# **Cortina Systems<sup>®</sup> LXT971A, LXT972A, LXT972M Single-Port 10/100 Mbps PHY Transceivers**

**Specification Update**

**Document Number 249354**

**Revision 13.0**

**Item 15: Detection of Illegal Symbols After SSD**

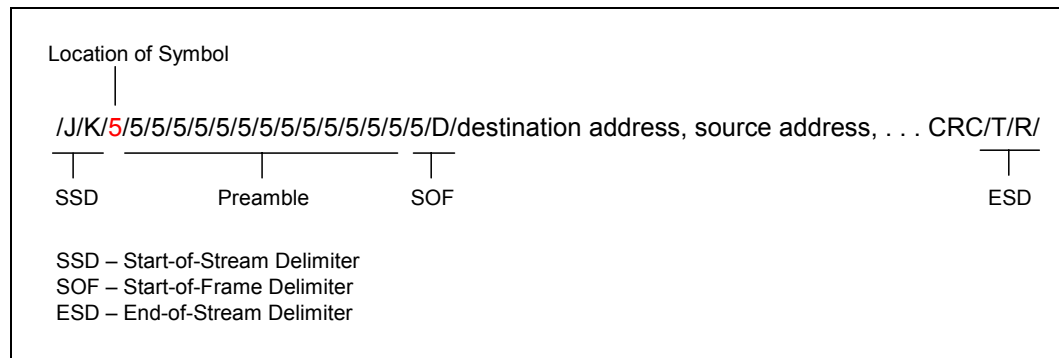
**Problem** An illegal symbol placed immediately after the SSD (preamble after JK) is not detected. However, any subsequent corrupt symbol will be detected.

**Implication** RXER does not assert if this symbol location is corrupted. However, an error in this location does not affect packet integrity.

**Workaround** Use the MAC layer protocol to detect corrupt symbols in the packet.

**Figure 10 Ordering Information Matrix - Sample**

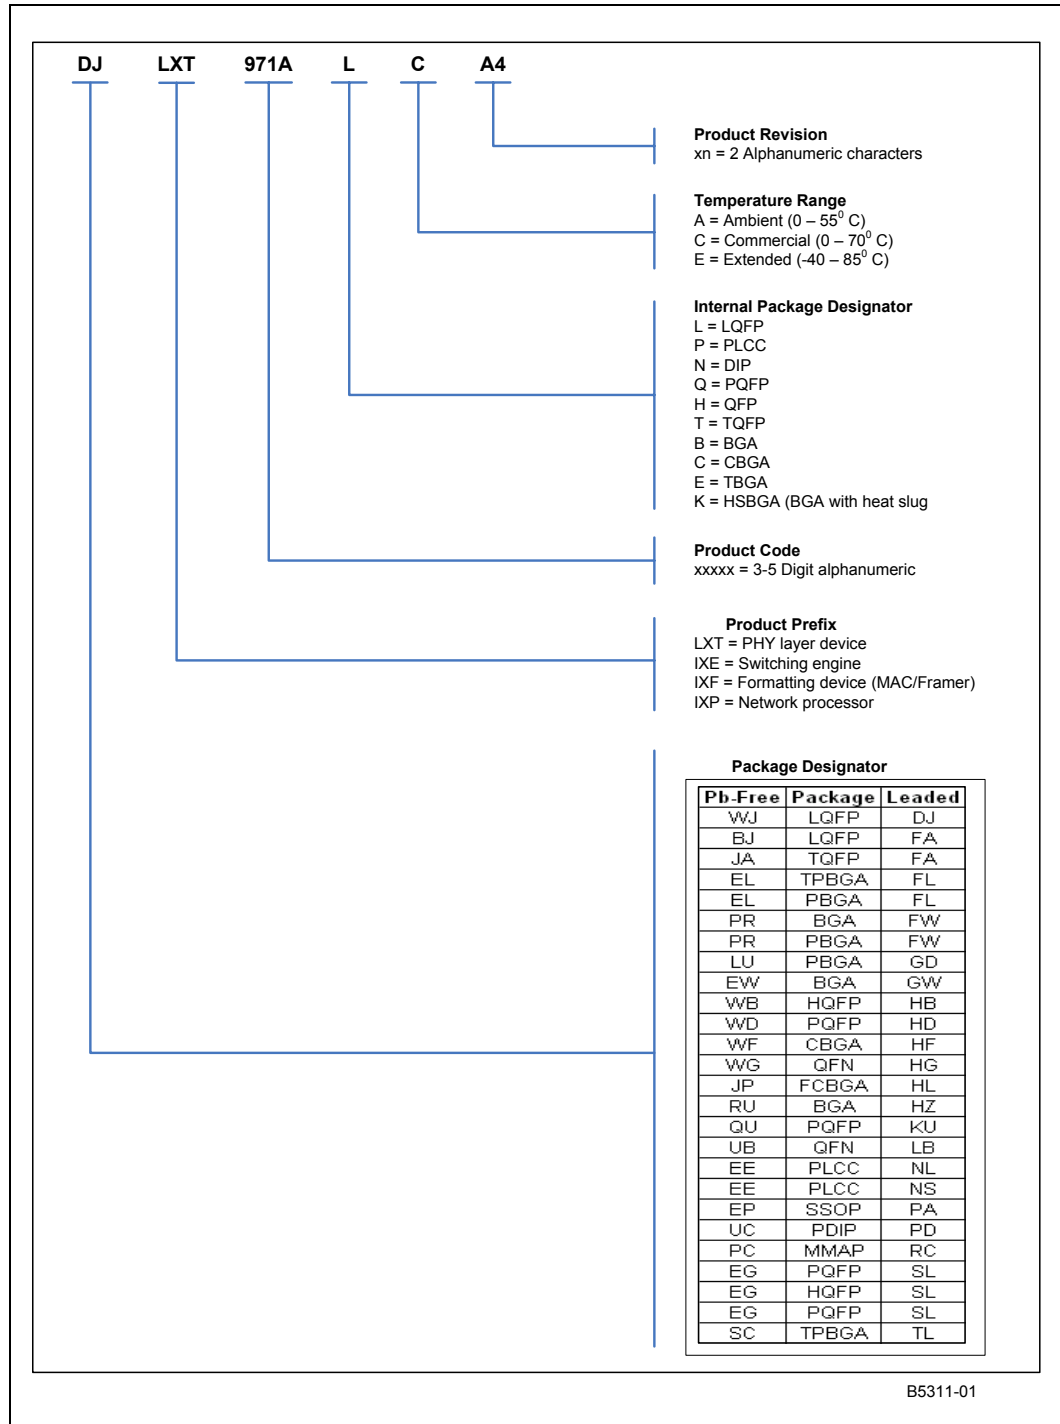
Change 2. The ordering information matrix changes as shown in [Figure 10](#).
